FINAL PLAT

PEARSON FARMS ADDITION

Re: Final Plat S/D 88-24 - PEARSON FARMS ADDITION

STAFF REPORT
(Final Plat; Preliminary Approved 4/21/88)

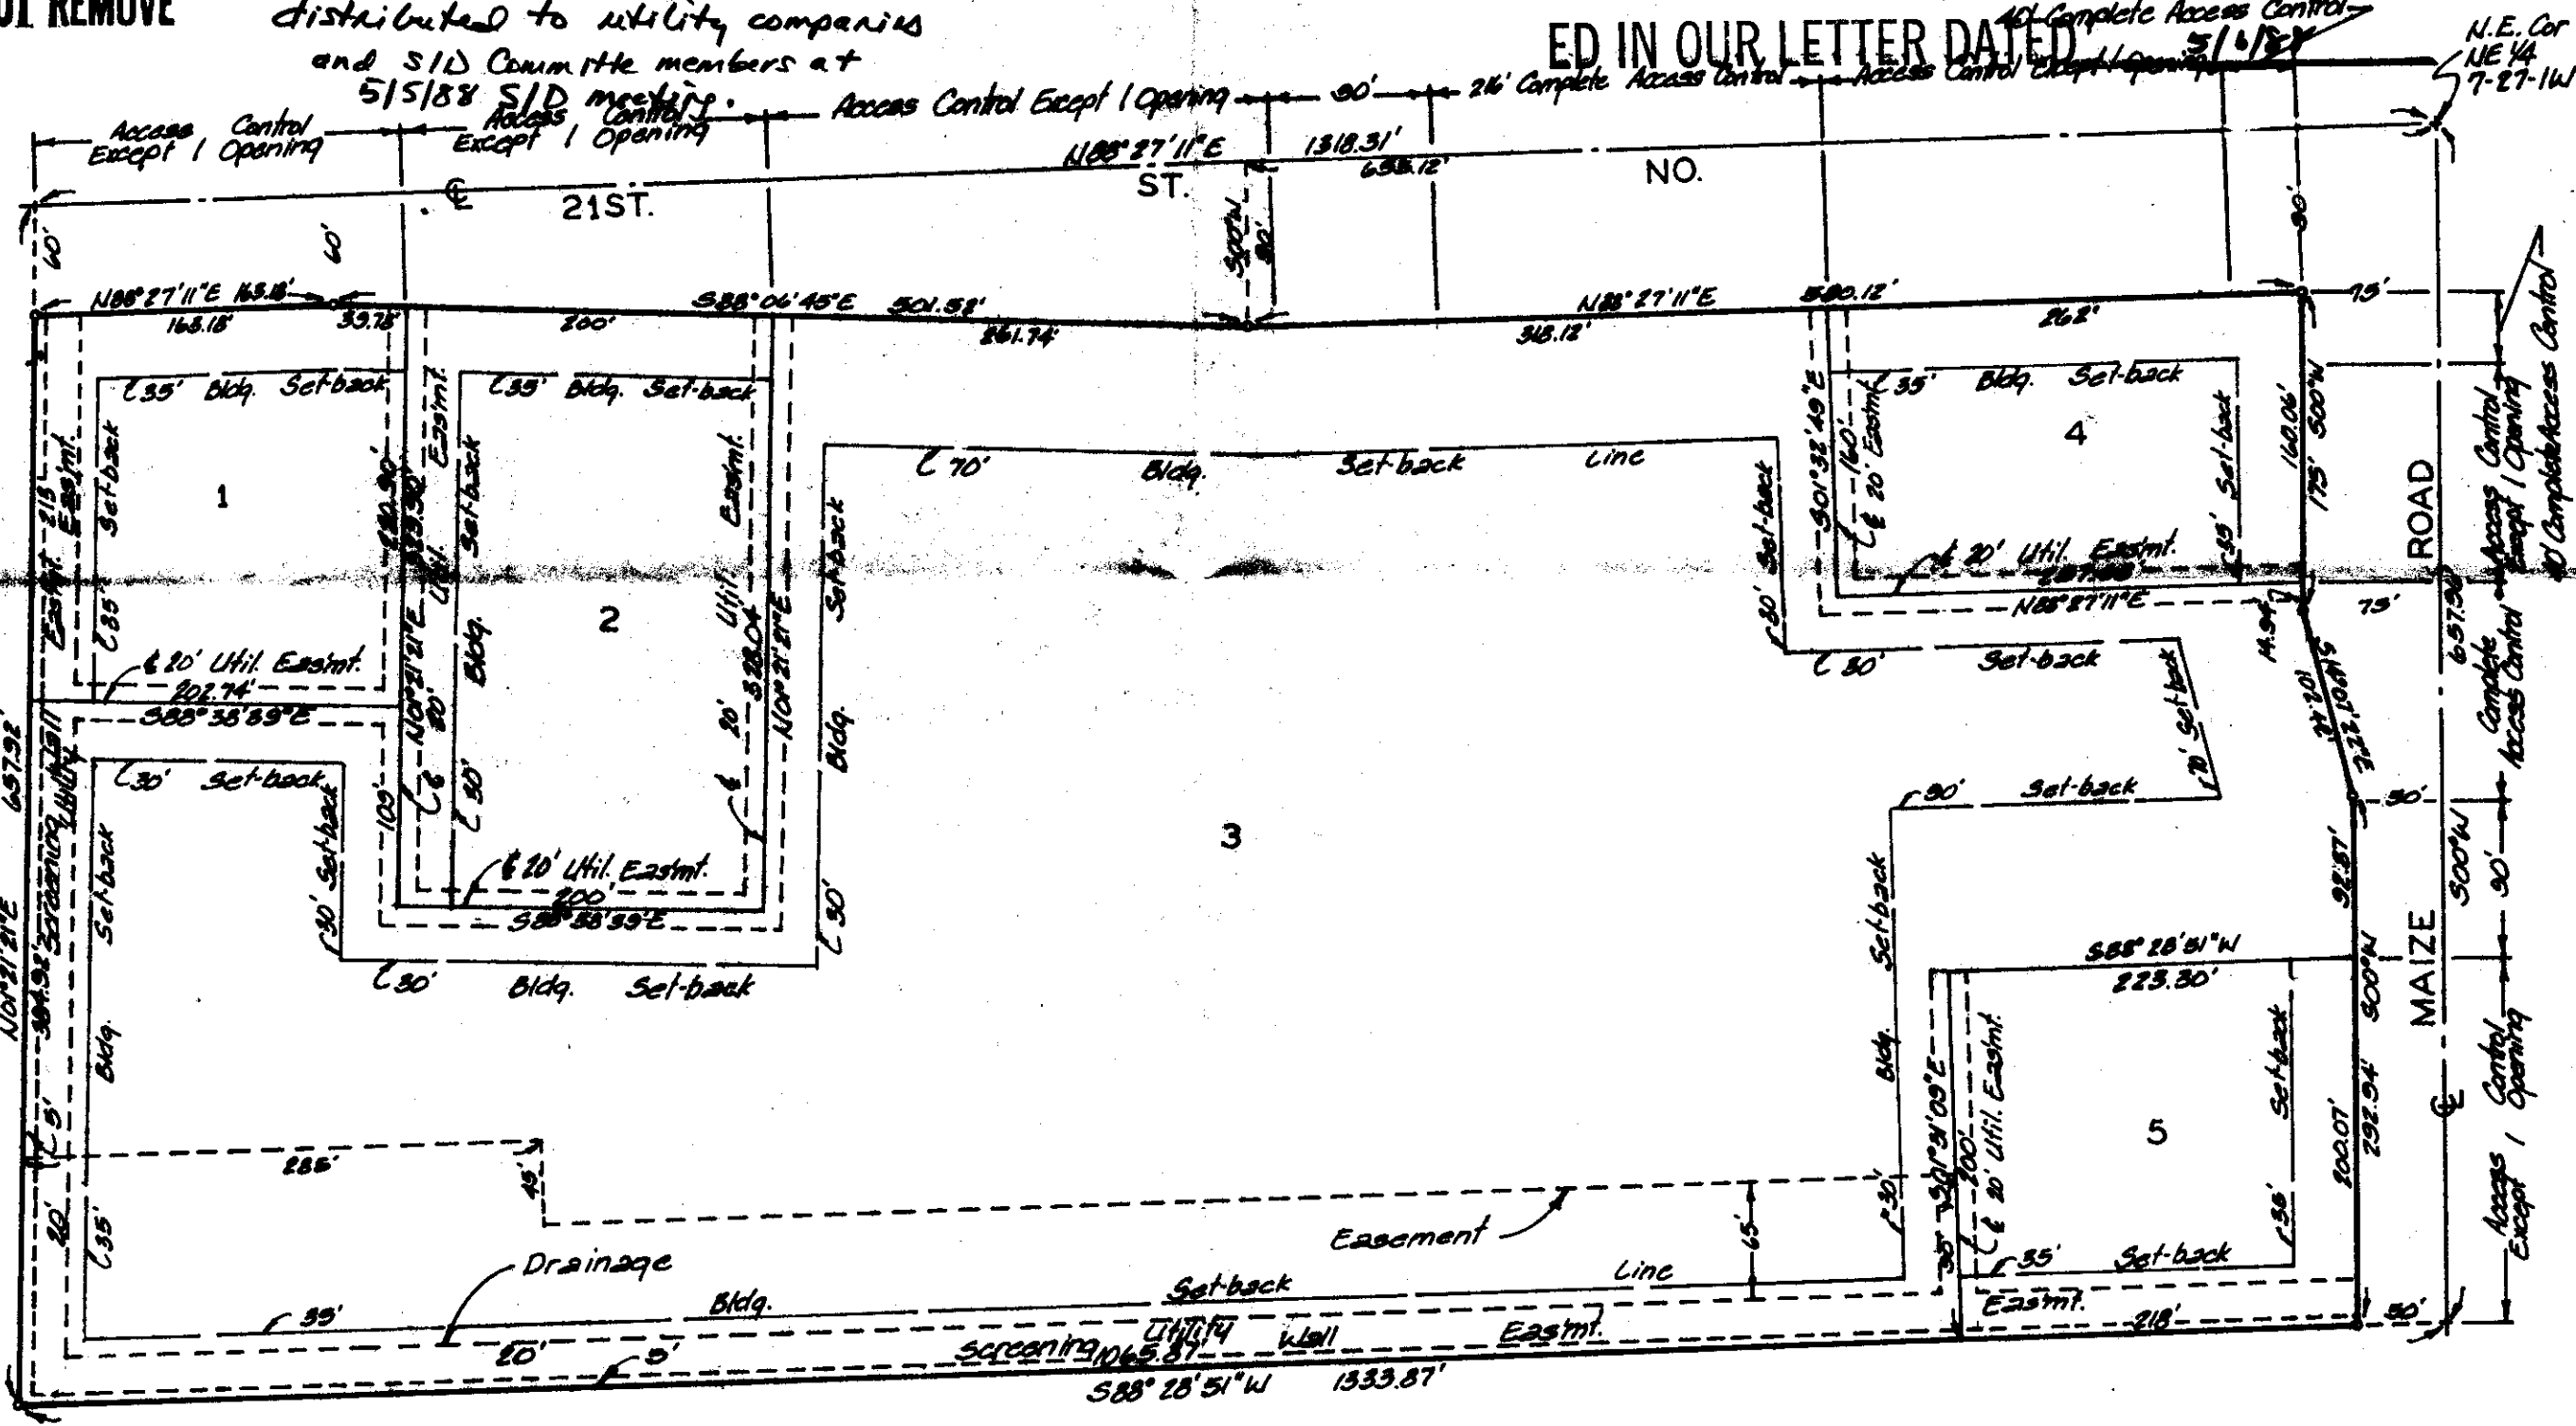
- L. The final plat tracing shall indicate the utility easements requested by K.G.&E. and Southwestern Bell. These easements are indicated on the surveyor's copy of the approved preliminary plat.

- N. On the final plat tracing, the platlor's text shall be amended to more clearly indicate the access openings being allowed from the lots to Maize Road and 21st Street. In particular, the 90-foot areas from Lot 3, intended for major entrances, needs to be more accurately described. It is suggested that the platlor's text simply state that, "access controls as depicted on the face of the plat are hereby dedicated". Also, the 90-foot wide areas on Lot 3 should be labeled on the face of the plat as areas of "access control except for one opening".

- O. On the final plat tracing, the perimeter of Lot 2 shall be reduced to match the boundaries of C.U.P. Parcel 2. On the preliminary plat, the configuration of Lot 2 was correctly shown. If the applicant desires to plat Lot 2 as shown on this final plat, an adjustment to the Community Unit Plan parcel descriptions is required.

- P. Perimeter closure computations shall be submitted with the final plat tracing. Section 5-101(C).
- Q. Recording of the plat within 30 days after approval by the City Council.
